## Model Royal 43 S/SE

### Pulley ref. no. 513 78 91-00 for the clutch

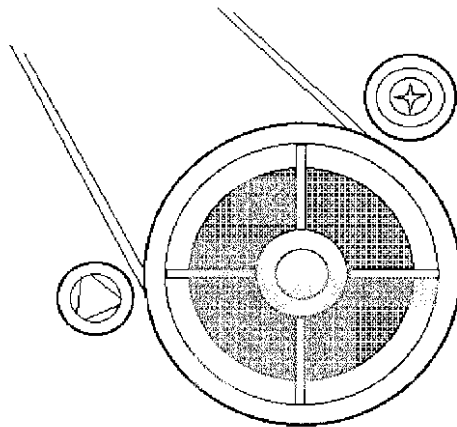
Lawn mowers manufactured during 930101-940311 may have a pulley for the clutch which wears against the belt guide. (See at the left of the illustration below).

This makes the lawn mower hard to pull backwards with the wheel drive disengaged.

Change the pulley to a new smaller pulley (054 mm).

Ref. no. 513 78 91-00 remains unchanged.
